STANDARD SUPPLY WAREHOUSE  
1575 TECHNOLOGY WAY  
ROCKWALL, TX 75032

SP2025-044: Amended Site Plan for an Expansion  
of an Existing Warehouse/ Manufacturing Facility  
at 1575 Technology Way

SHEET  
A2.0  
EXTERIOR  
ELEVATIONS

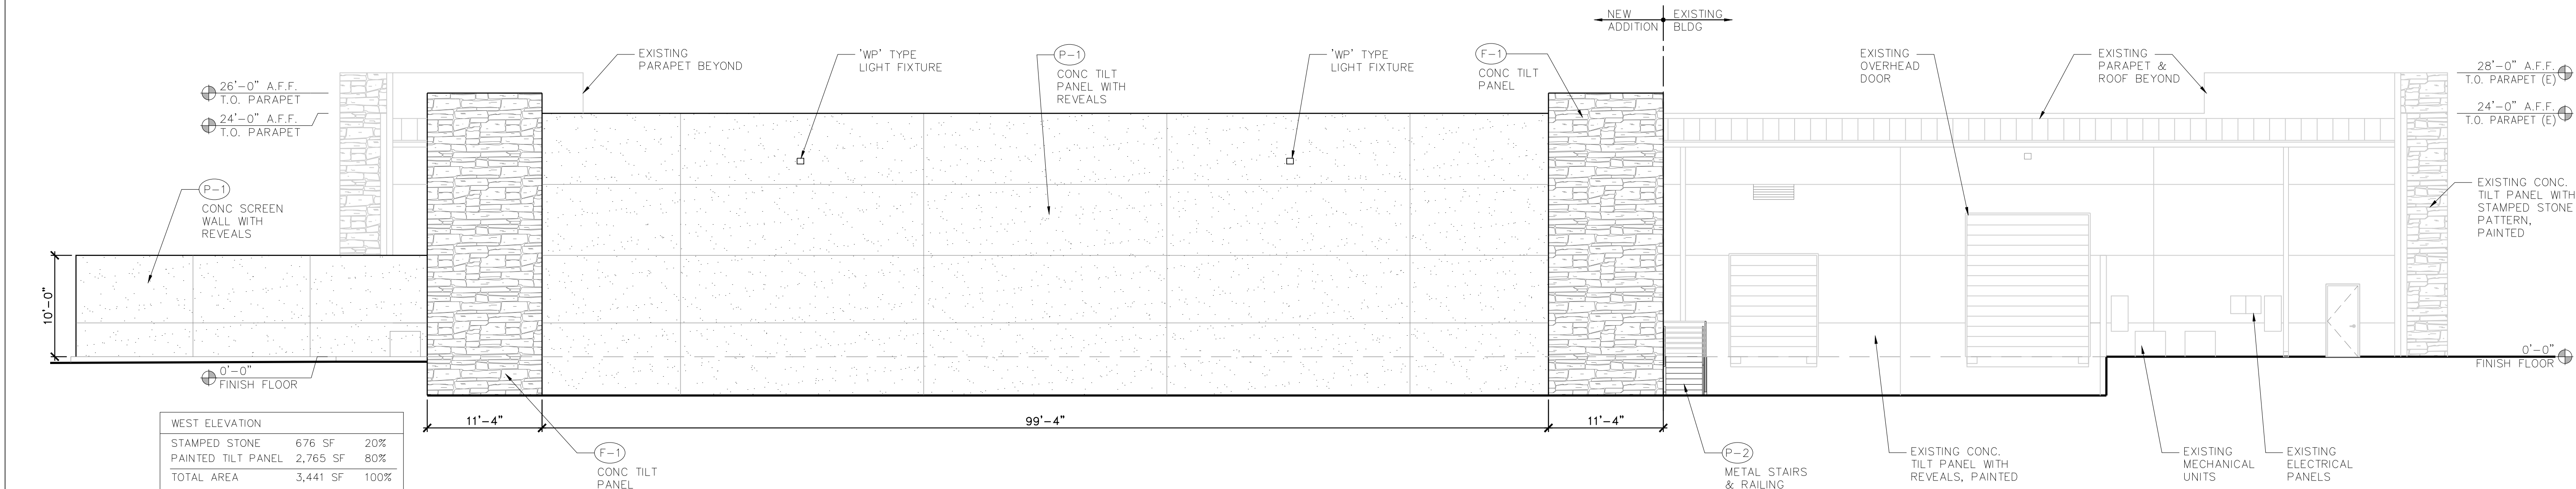
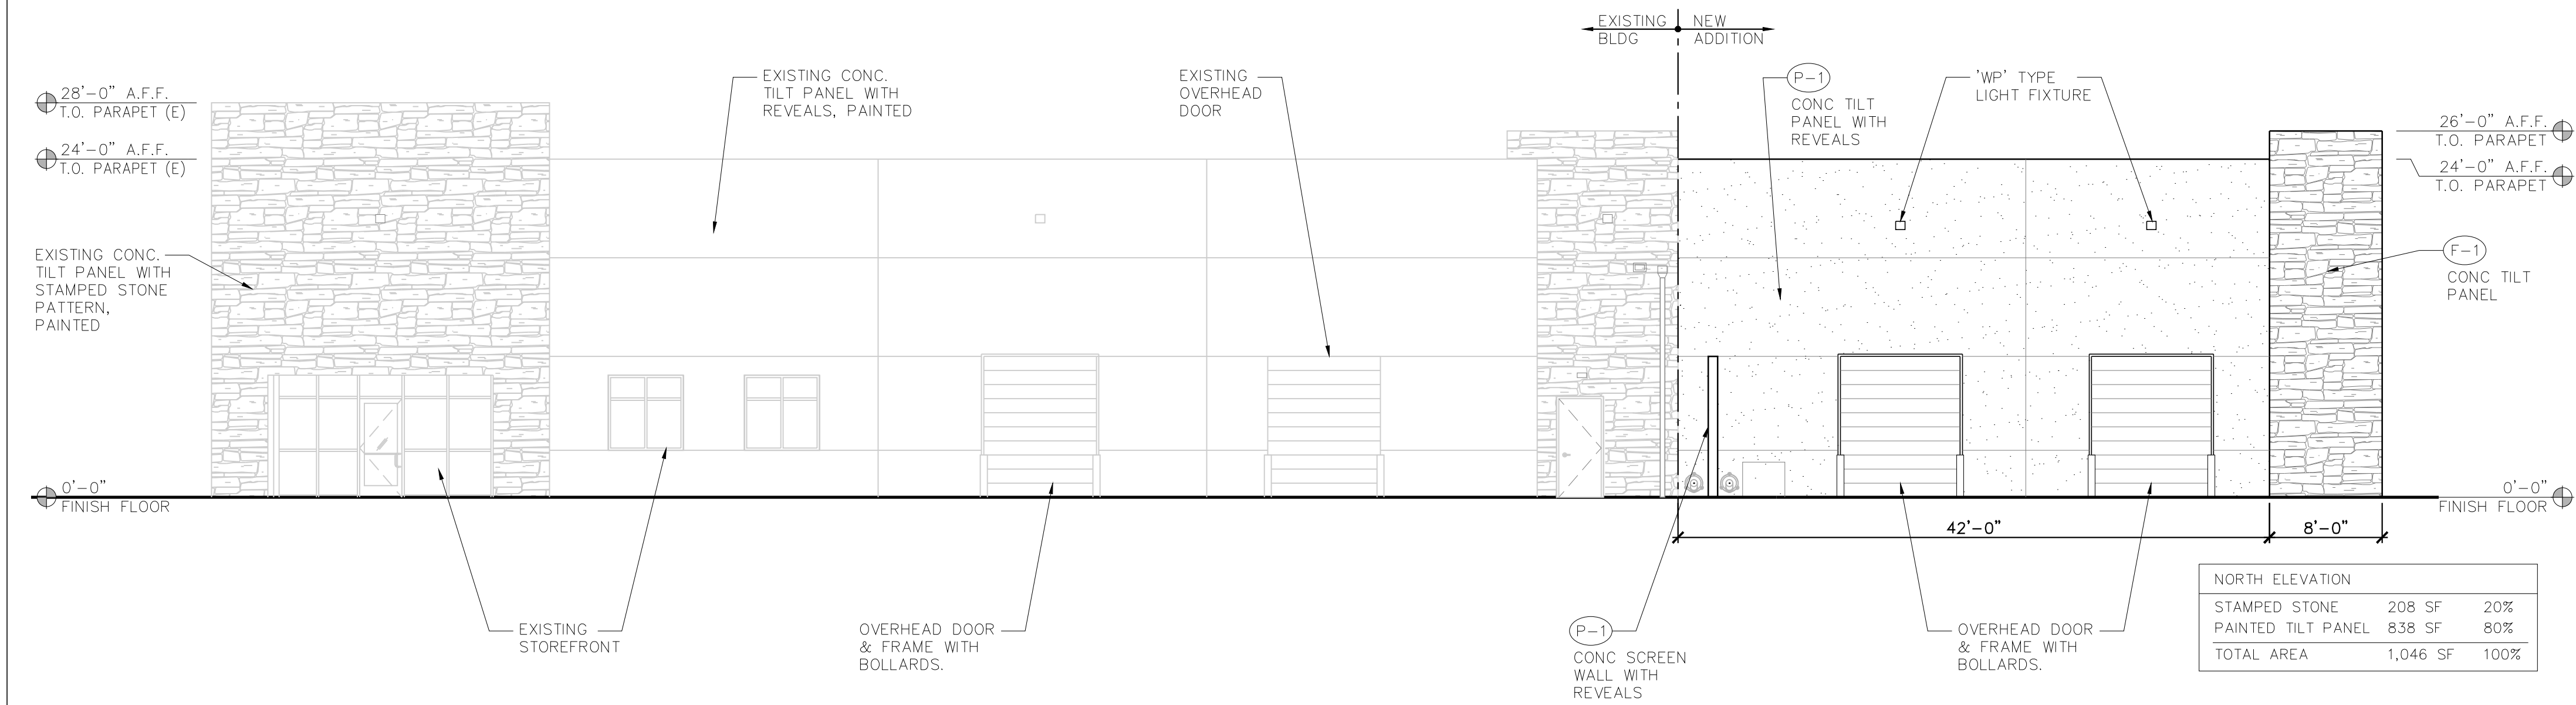
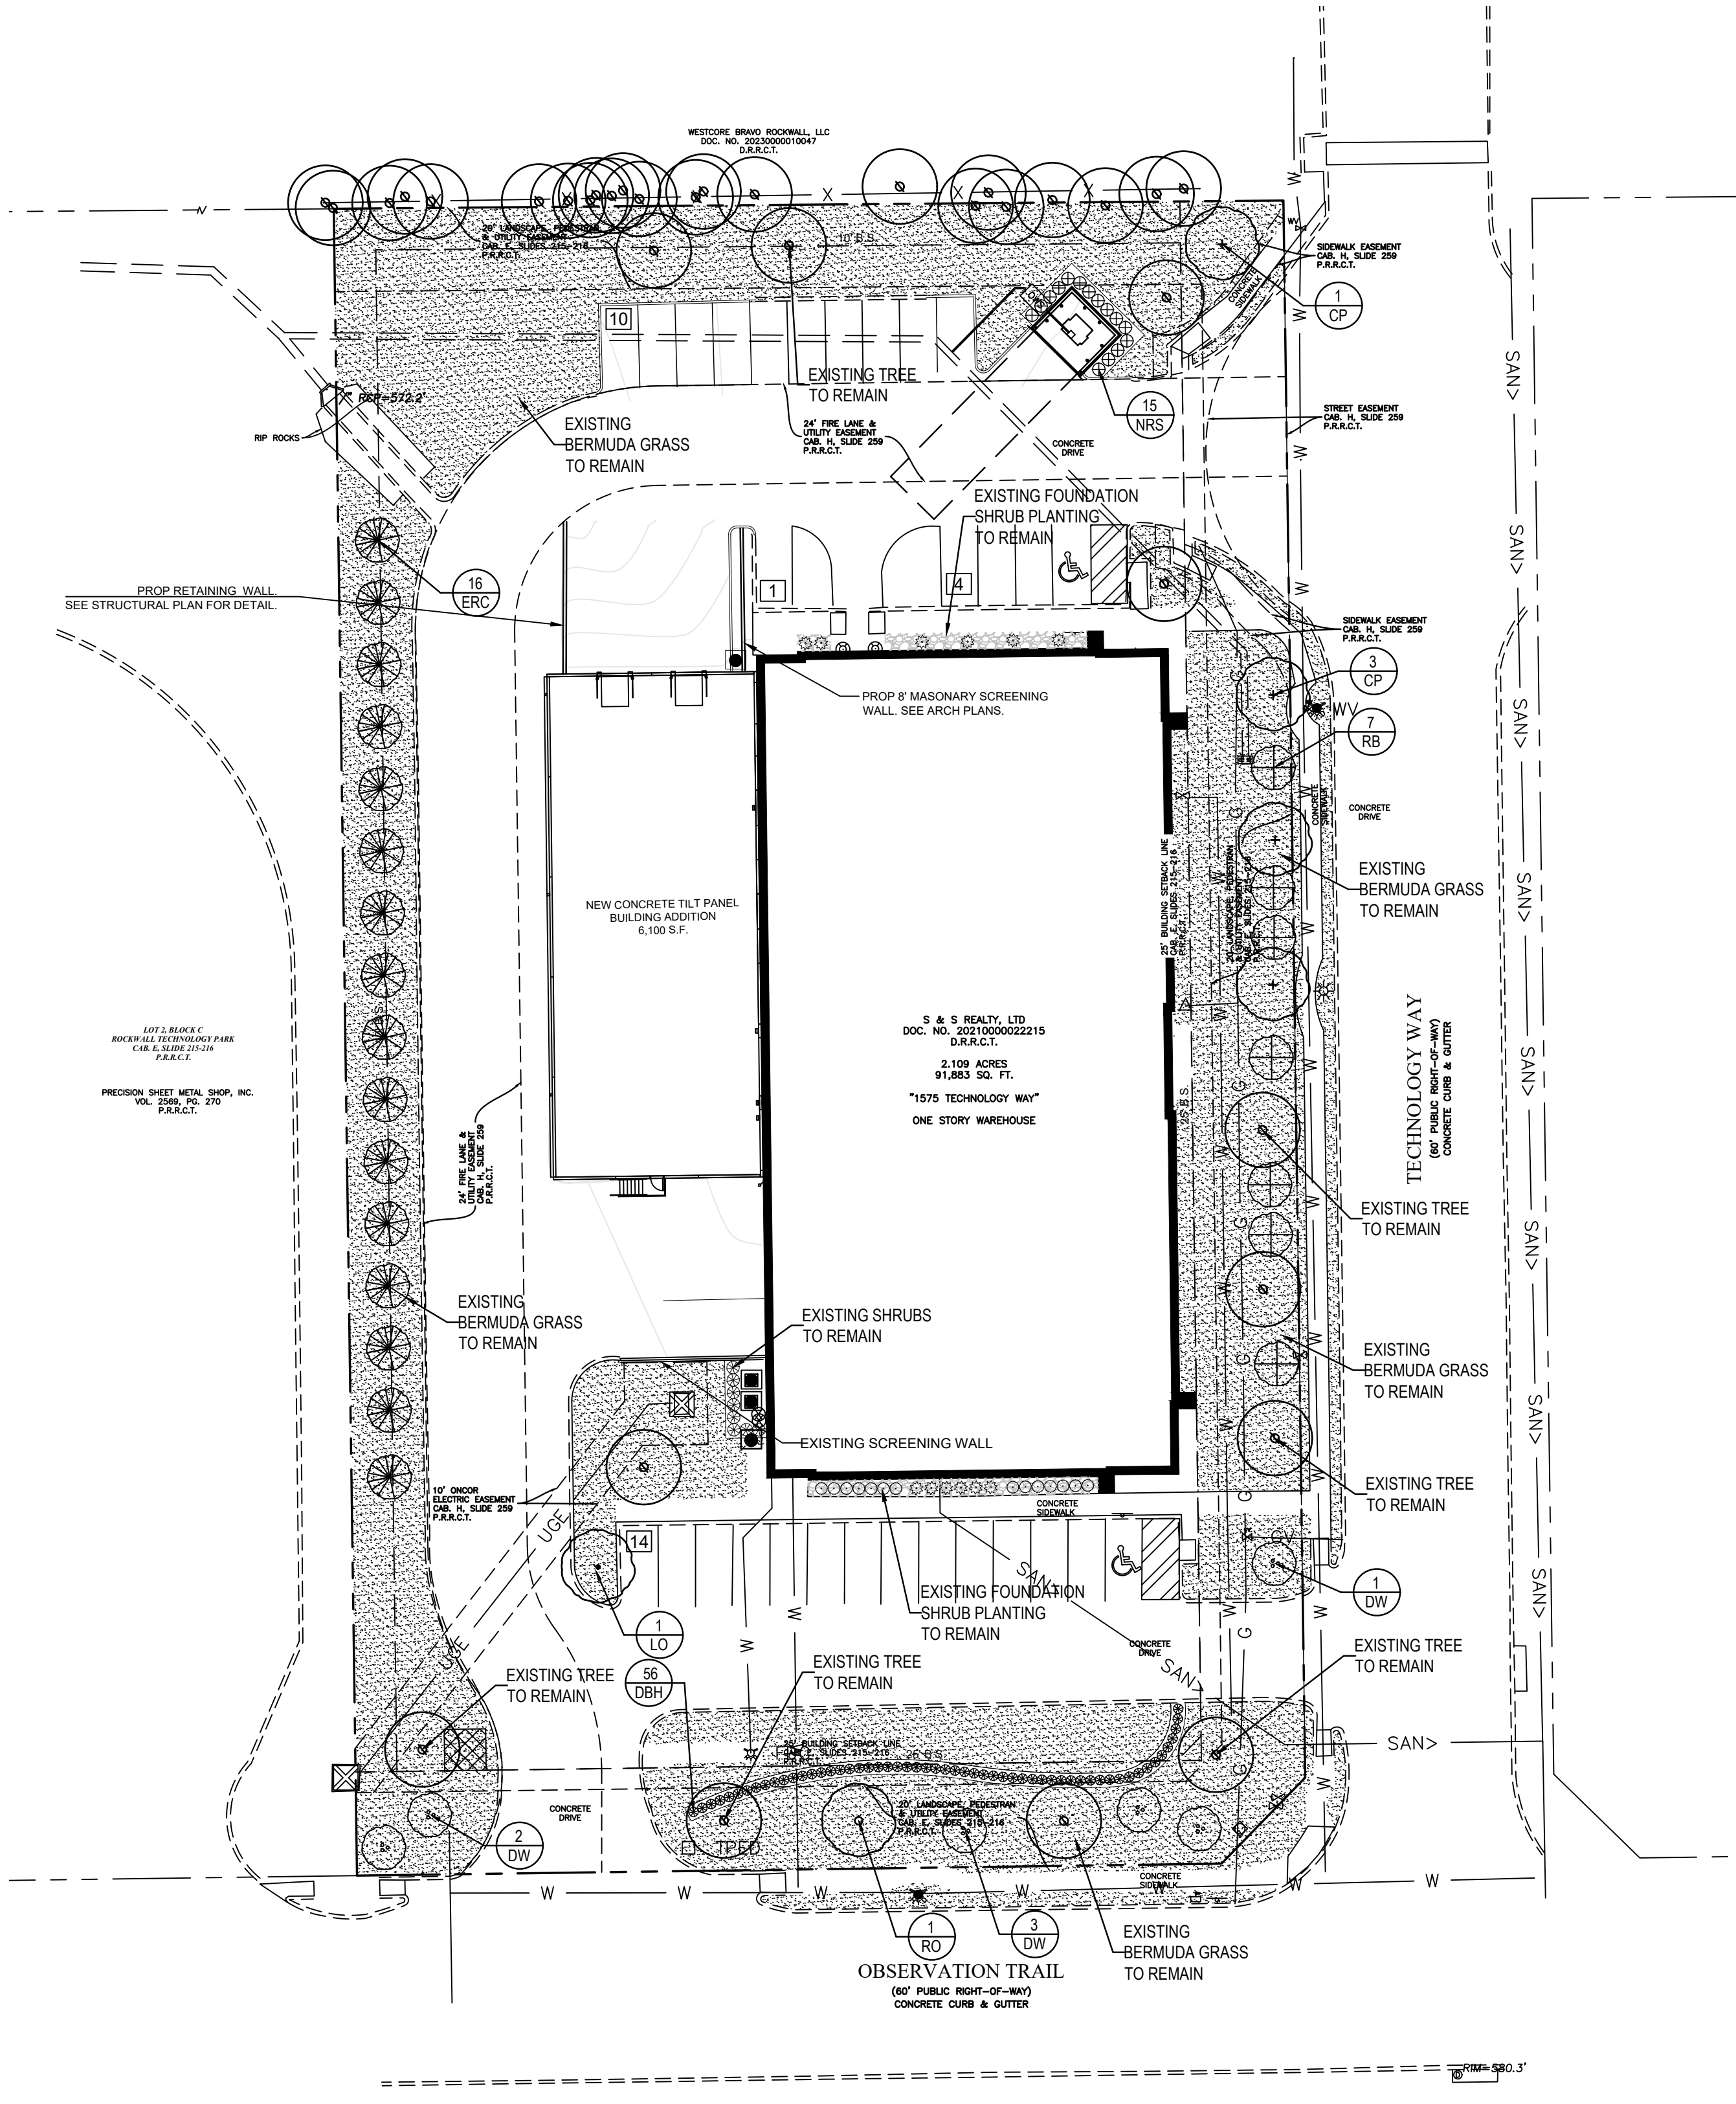
11. Please provide the material percentages for each façade of the building. (Subsection 04.01, Article 05, UDC)  
**Material percentages have been added to elevation sheet A2.0 as requested.**
